• • ADDENDUM # 2 ••

**PROJECT NUMBER: 130012-59
EASTERN REGIONAL WATER RECLAMATION FACILITY
OPERATIONS BUILDING RENOVATION
DUE DATE: 08/27/2025 @ 1:30 PM**

**EASTERN REGIONAL WATER RECLAMATION FACILITY
OPERATIONS BUILDING RENOVATION
PROJECT NO. 130012-59**

**CHANGES TO BID DOCUMENTS – SPECIFICATIONS AND CONTRACT
DOCUMENTS**

VERTICAL CIRCULATION STAIR PLANS & SECTIONS

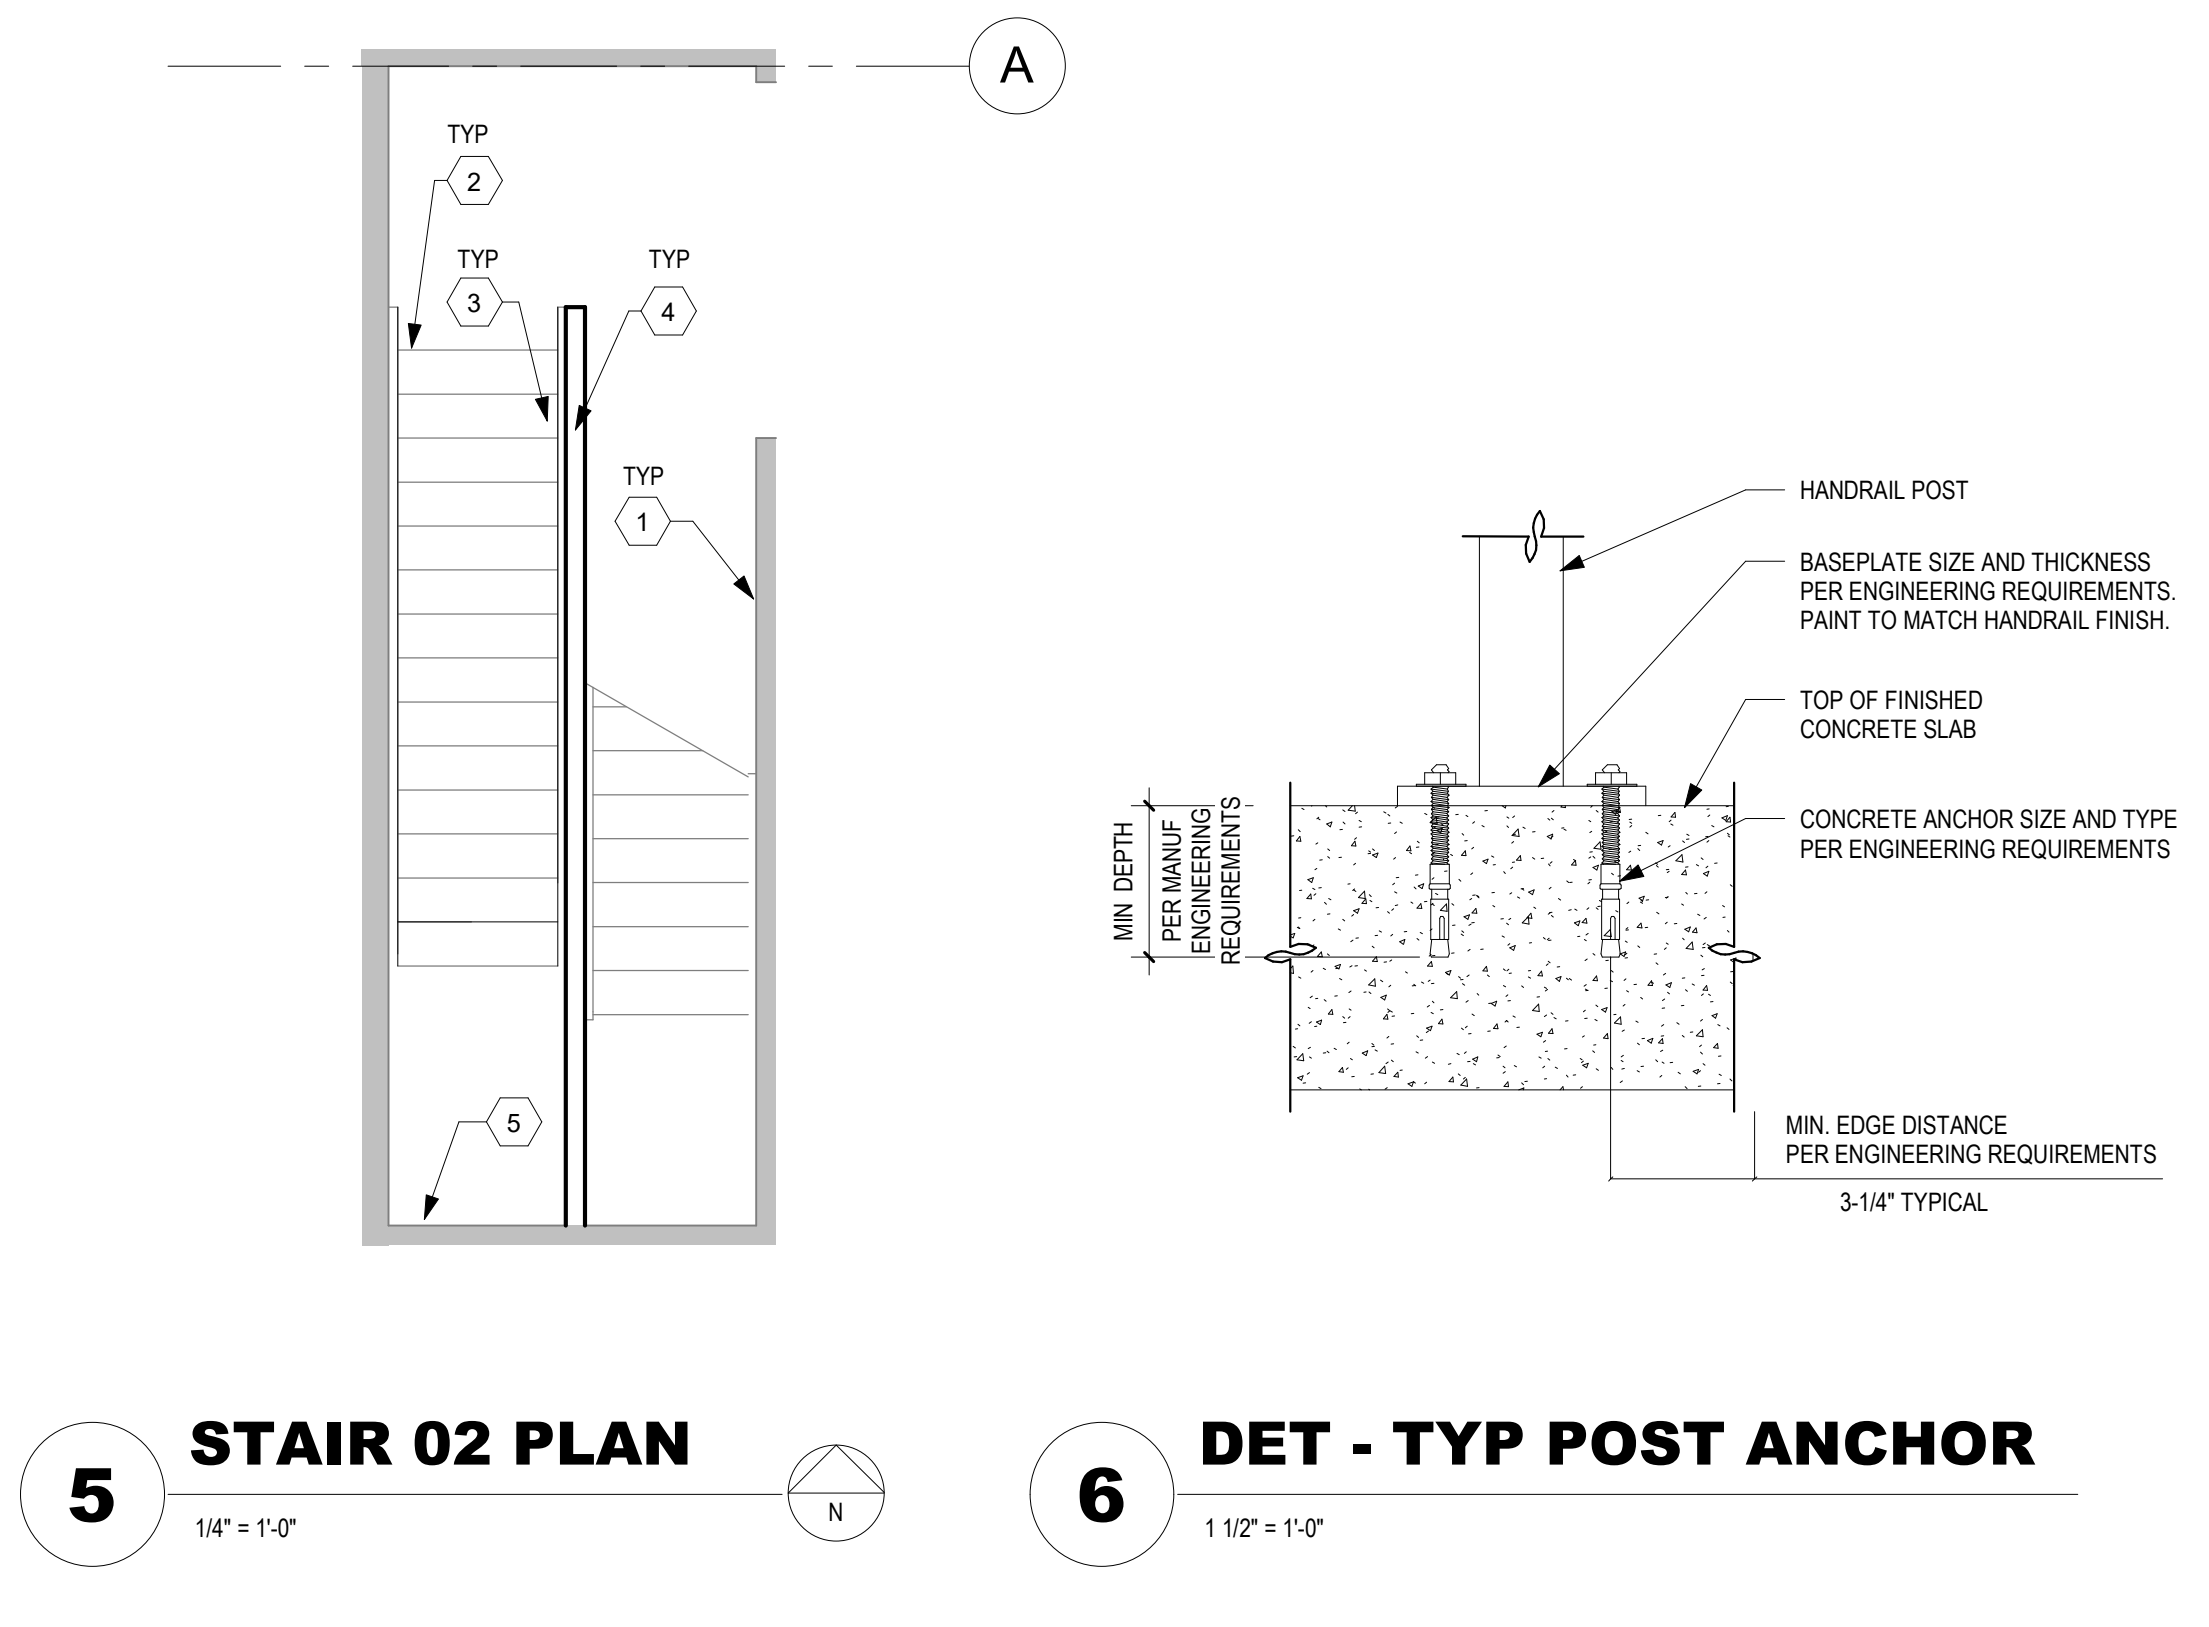
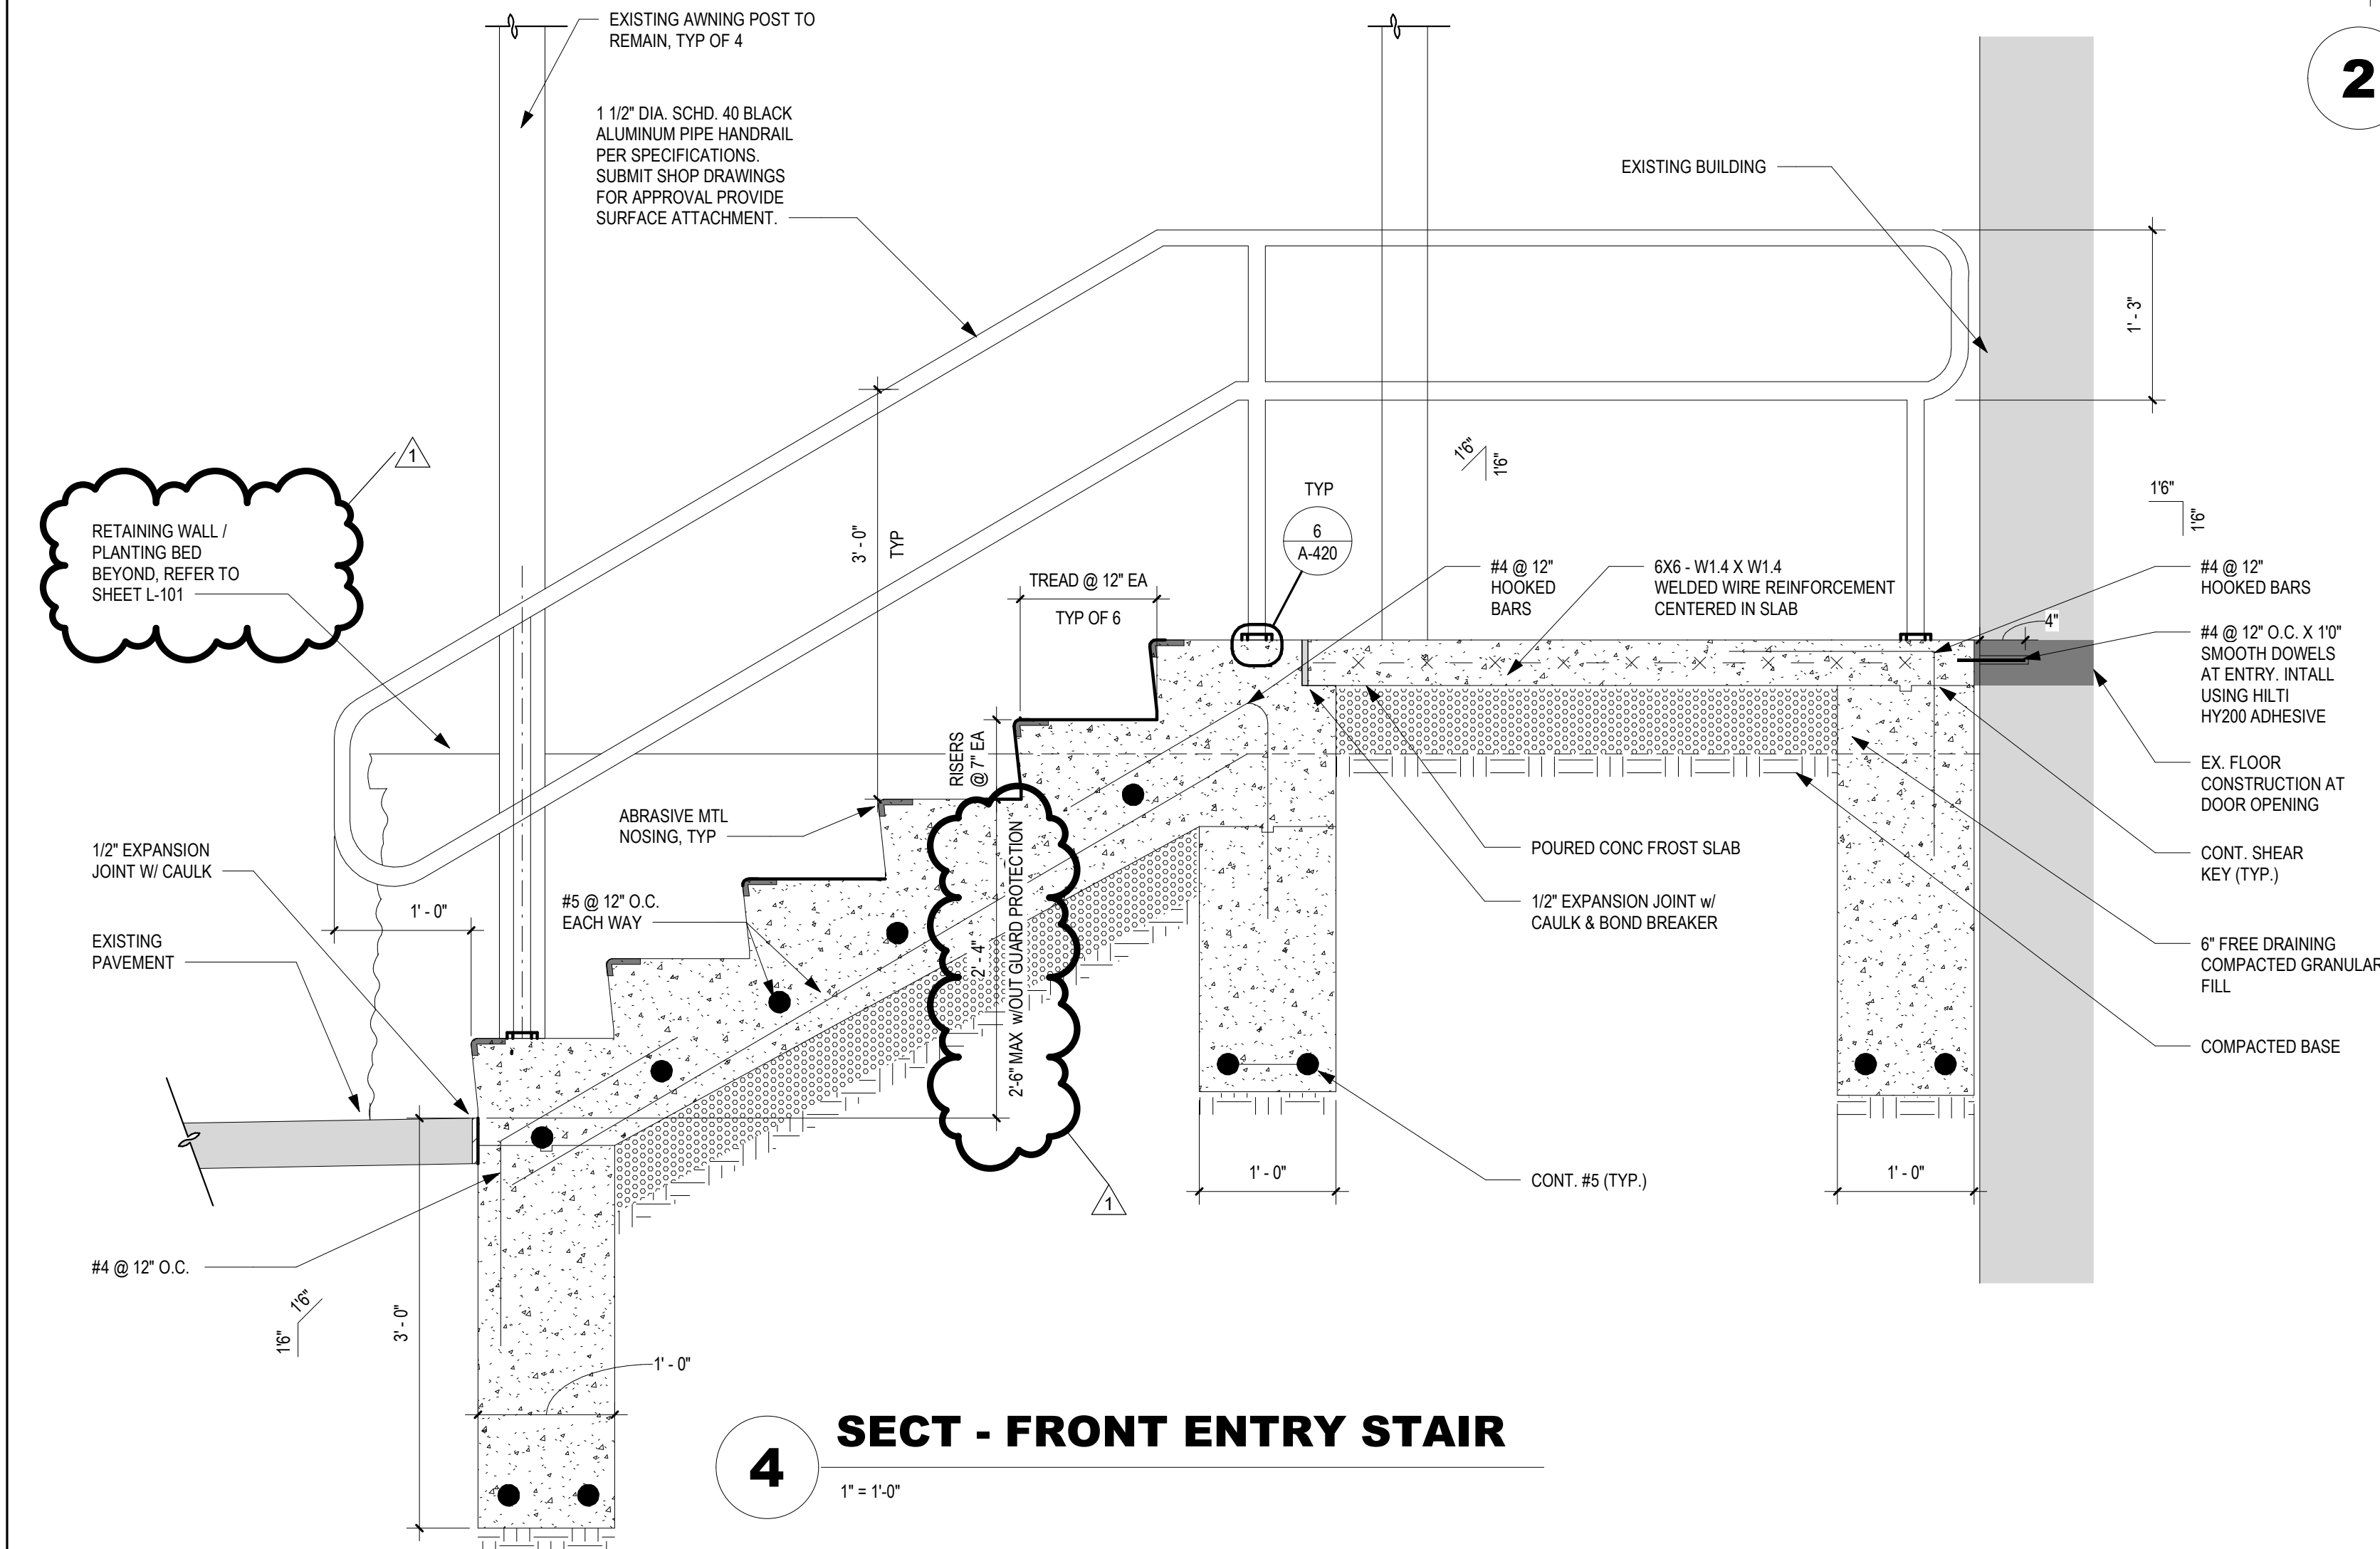
- a. Add CODED NOTE 9 per attached sheet.
9. Sheet A-420 VERTICAL CIRCULATION STAIR PLANS & SECTIONS
 - a. Add CODED NOTE 14 per attached sheet.
 - b. Add notes to section 4/A-420 per attached sheet.

| CODED NOTES | |
|-------------|--|
| 14 | LINE OF RETAINING WALL, REFER TO L-101. MAINTAIN 2'-6" MAXIMUM RISE W/OUT GUARD PROTECTION @ NEW CONCRETE STAIRS. |
